Response to the Reviewers Comments

Author reply to RC2 egosphere-2023-2458 (NHESS)

Paper title: Detection of flooding by overflows of the drainage network: Application to the urban area of Dakar (Senegal)

Figure: (a) Location of the study area; (b) Digital Terrain Model; (c) soil type distribution

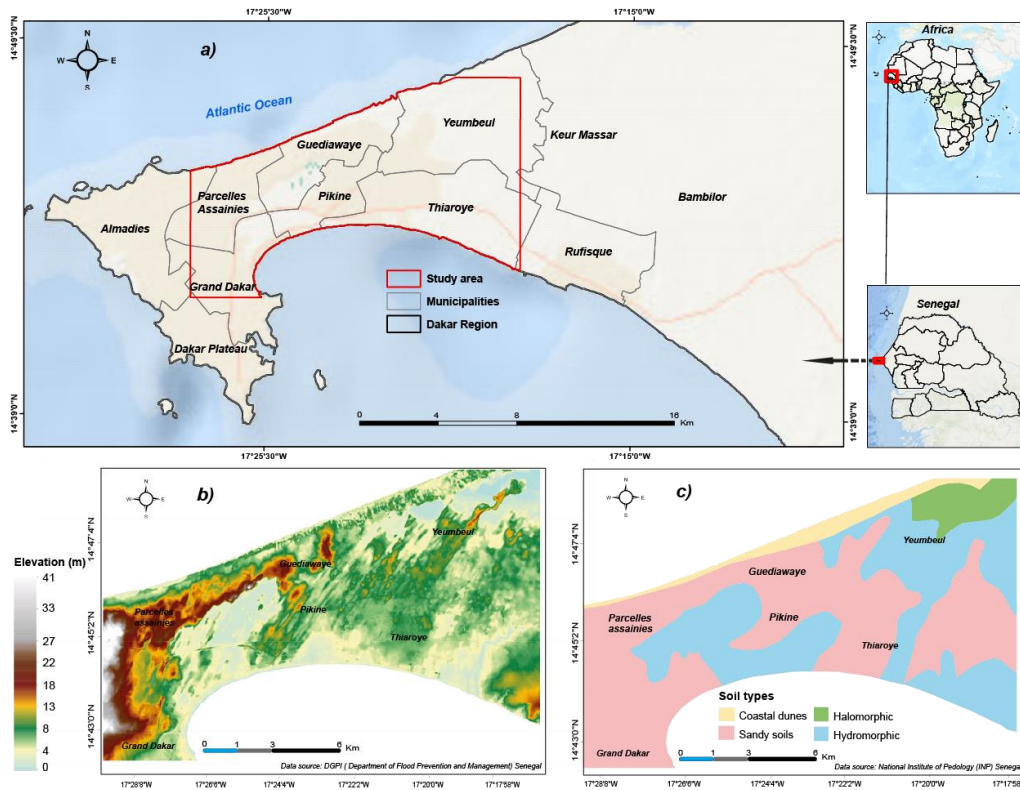
Figure 1. Please insert the north arrow into the map

The north arrow was inserted into the map in Figure 1. An altitude map and a soil types map will be also added to provide a better description of the study area.

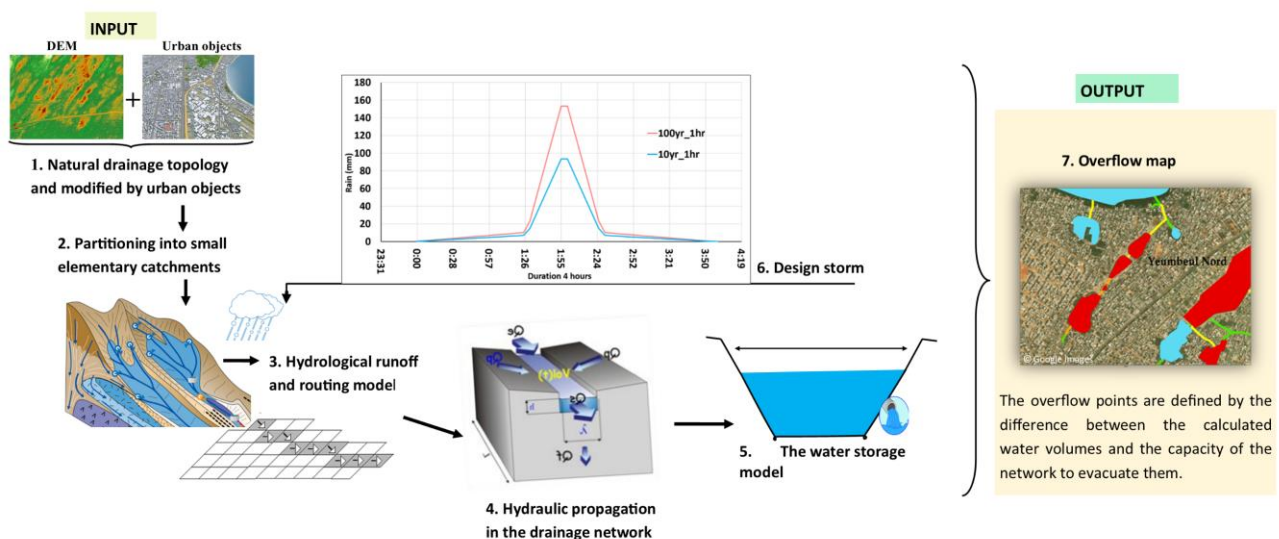
- Please insert a flow chart of data processing

A flow chart of the method will be inserted in section 3.
